HISTORIC LANDMARKS COMMISSION

November 18, 2014

SUBJECT: NEW CONSTRUCTION REQUEST (NC14-06) BY TRACY & DONNA BLACK TO
CONSTRUCT A COMMERCIAL BUILDING AT 1619 MARINE DRIVE

SUBJECT: NEW CONSTRUCTION REQUEST (NC14-05) BY STEELE ASSOCIATES
ARCHITECTS TO CONSTRUCT A COMMERCIAL BUILDING AT 1122 DUANE
STREET

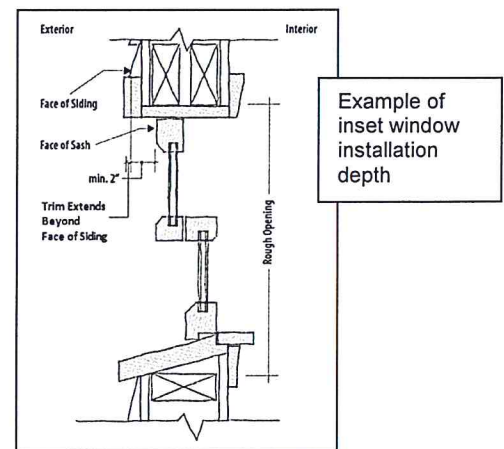
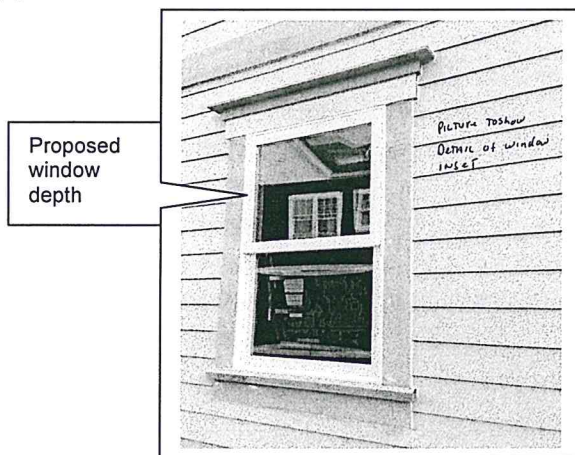
The windows should be installed inset similar to a historic depth so that the windows do not protrude beyond the plane of the facade as indicated in the graphic (Condition 2). The applicant has shown the window inset similar to a window in the Gateway Overlay Area. However, the historic depth should be as per the example below which appears to be more than the picture provided by the applicant.

1. All glass shall be clear and not tinted or reflective except as required by building codes.
2. Windows shall be installed inset similar to a historic depth so that the windows do not protrude beyond the plane of the facade
3. Significant changes or modifications to the proposed plans as described in this Staff Report shall be reviewed and approved by the Historic Landmarks Commission.

SECTION LOOKING NORTH

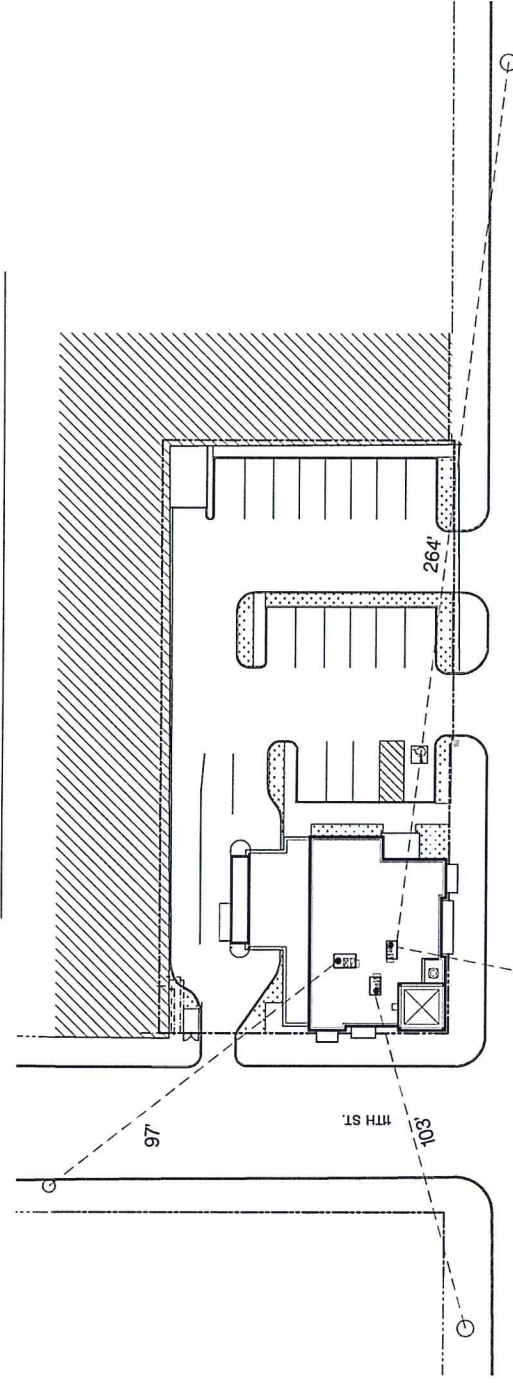
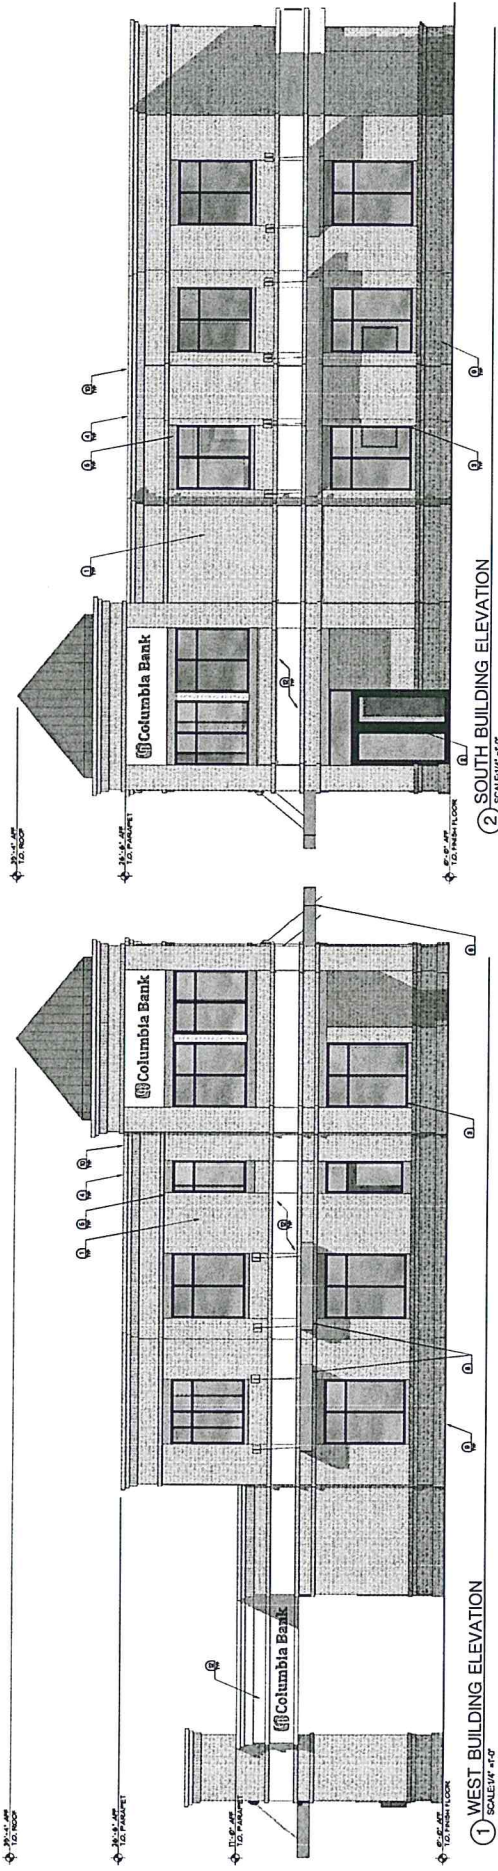
Roof Top Unit Sightlines: Please reference plan and section profile document indicating the maximum distance where the parapet blocks a pedestrian's view of the RTU. Distances are from 97'-0", 103'-0", 164'-0" and 264'-0" feet away from the building.

COLUMBIA BANK

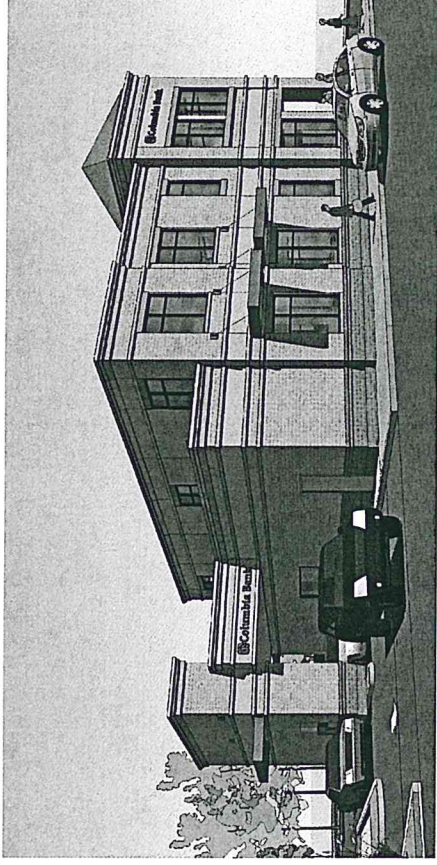
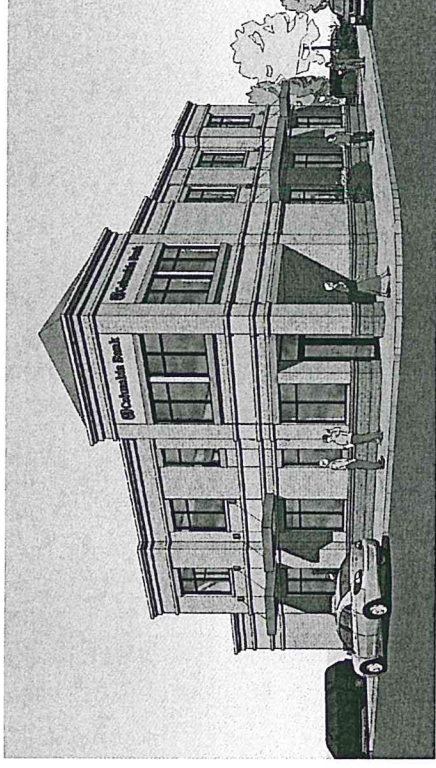
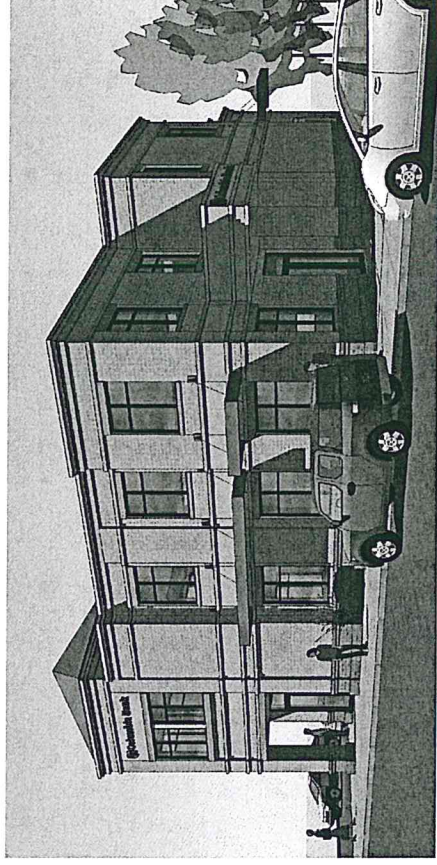
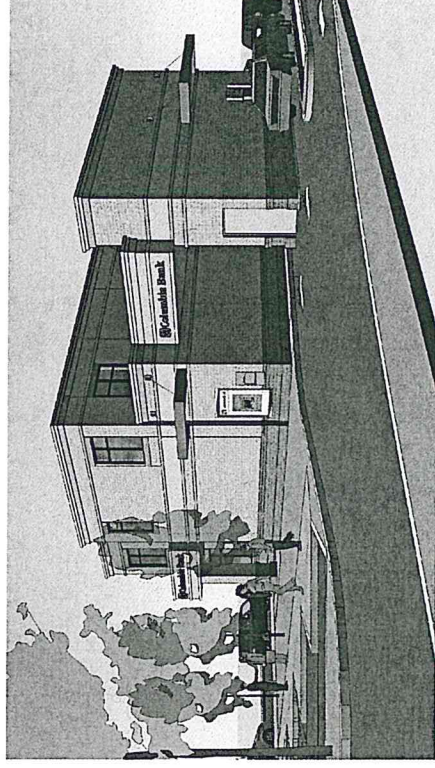
This letter is a response to the HLC requests to address the metal seam standing roof color, providing physical samples of the exterior materials, and presenting the location of the roof top units (RTU's) relative to sight lines from various viewpoints.

Owner-Architect response: Company branding colors and materials are very important to Columbia Bank. Columbia Bank respectfully requests that the Commission reconsider the current proposal of a blue standing seam metal pyramid. We hope the following bullet points justify the proposal to the Commission:

- **Accent Only:** Steele Associates has worked with City staff to provide the branding color as an accent material to the rest of the project. Traditionally Columbia Bank metal seam roofs are sloped and cover the entire building; a visually prominent feature. The proposed pyramid is a small percentage of the roof overall. It was also purposely set back from the parapet so to not interfere with the horizontal banding required by the City.
- **Low Profile and Scale:** Pedestrian level views from the street (see 3-D images) indicate that the pyramid roof is partially obscured. The pyramid is at a low profile and scale compared to the rest of the building.
- **Terra Cotta blue tiles:** This option was reviewed, but terra cotta roof tiles are not part of the bank's branding. Terra cotta also suggests Asian and Mediterranean styles.

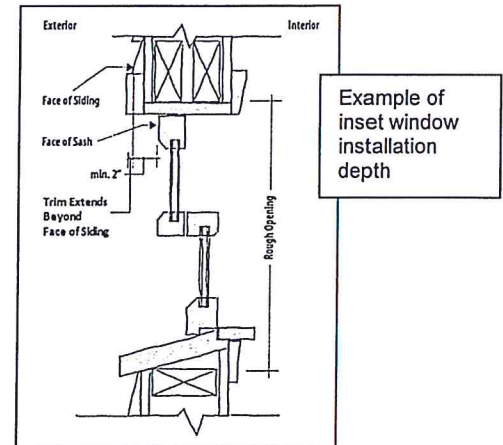
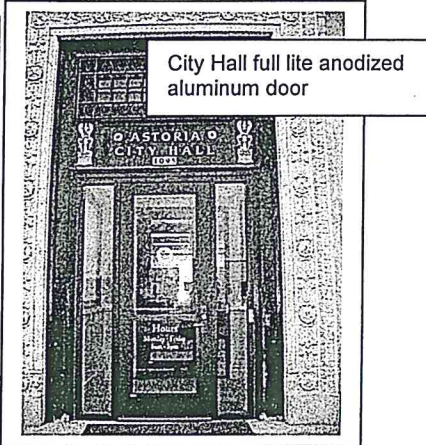
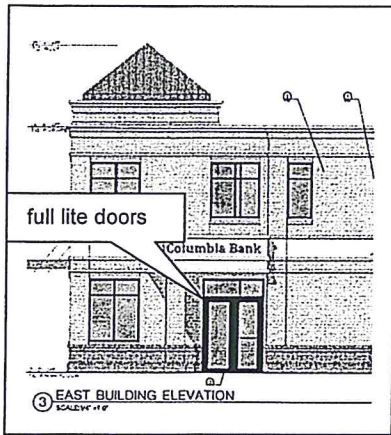
The windows should be installed inset similar to a historic depth so that the windows do not protrude beyond the plane of the facade as indicated in the

1. All glass shall be clear and not tinted or reflective.
2. Windows shall be installed inset similar to a historic depth so that the windows do not protrude beyond the plane of the facade
3. Significant changes or modifications to the proposed plans as described in this Staff Report shall be reviewed and approved by the Historic Landmarks Commission.
